# SERVICE LETTER

No. 362B

December 11, 1974

Modification of Windshield Top Attachment

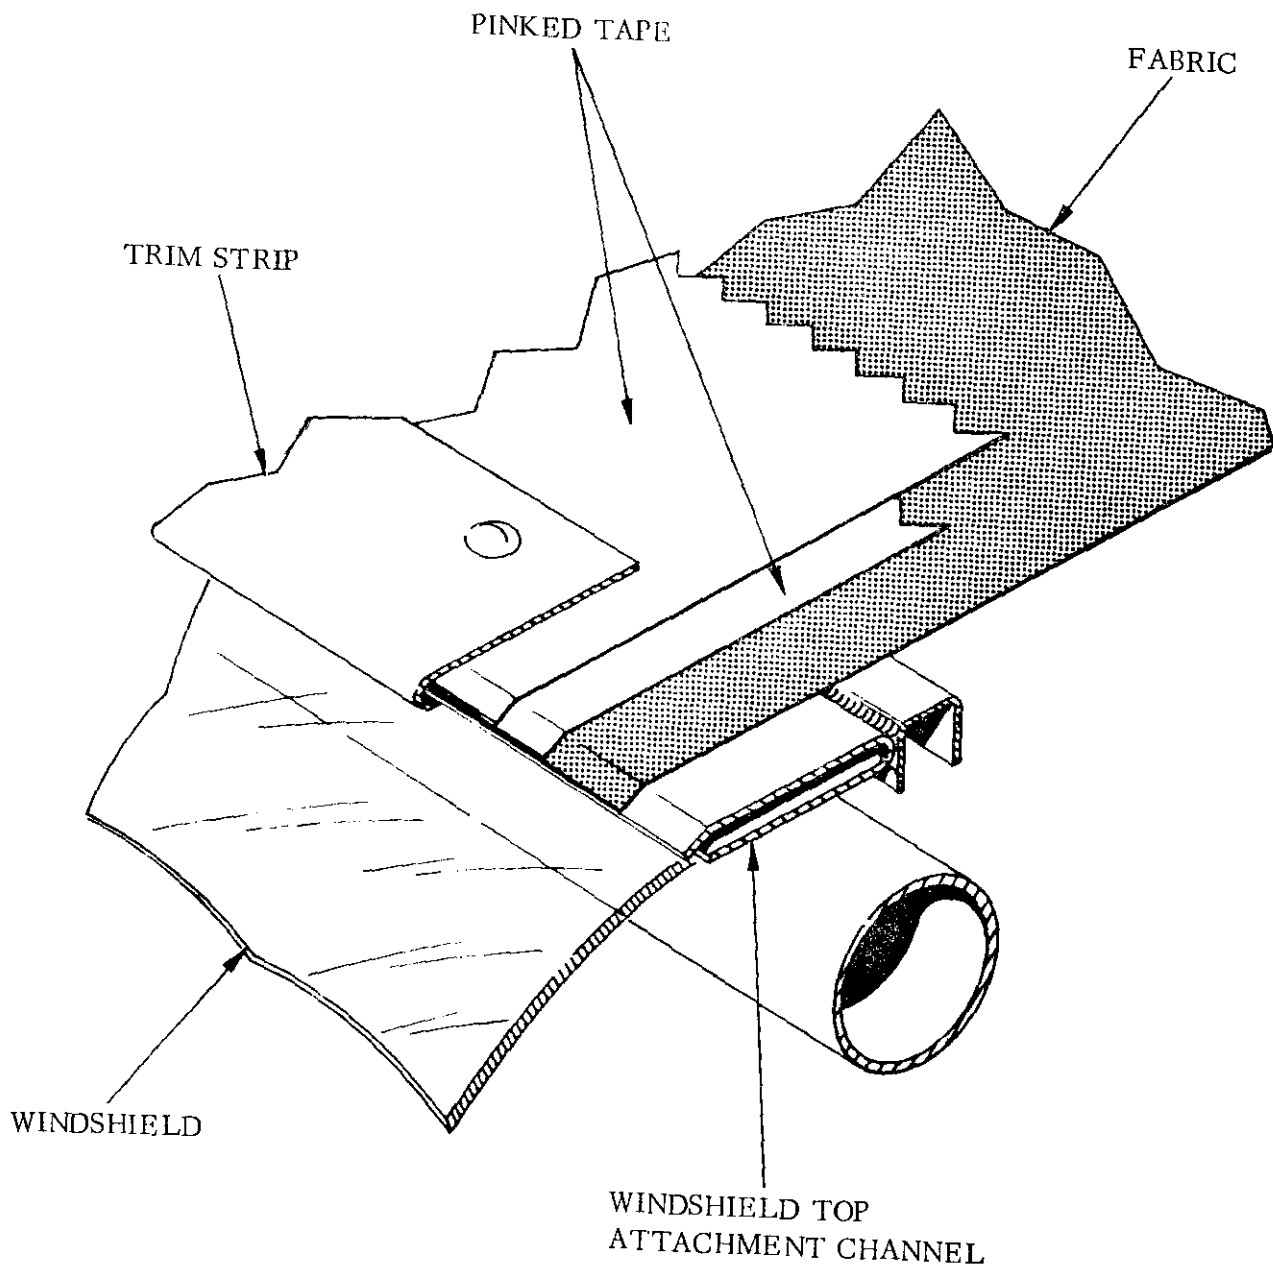
To provide material and instructions to reinforce the area where the fabric attaches to the fuselage under the windshield top and/or directly over the rear edge of the windshield top attachment channel on the above referenced aircraft. The attached sketch illustrates this area.

Contained in Fuselage Fabric Trim Strip Installation Kits, Piper part numbers 754 404 and 760 799 (reference Material Required, below).

1. Applies to PA-15, PA-16, PA-17 and PA-20 aircraft listed above, and PA-22 aircraft serial numbers 22-1 to 22-7630 incl.: One (1) each per aircraft Fuselage Fabric Trim Strip Installation Kit, Piper part number 754 404, at \$2 suggested unit retail price.
2. Applies to PA-12 and PA-14 aircraft listed above: One (1) each per aircraft Fuselage Fabric Trim Strip Installation Kit, Piper part number 760 799, at \$4.58C suggested unit retail price.
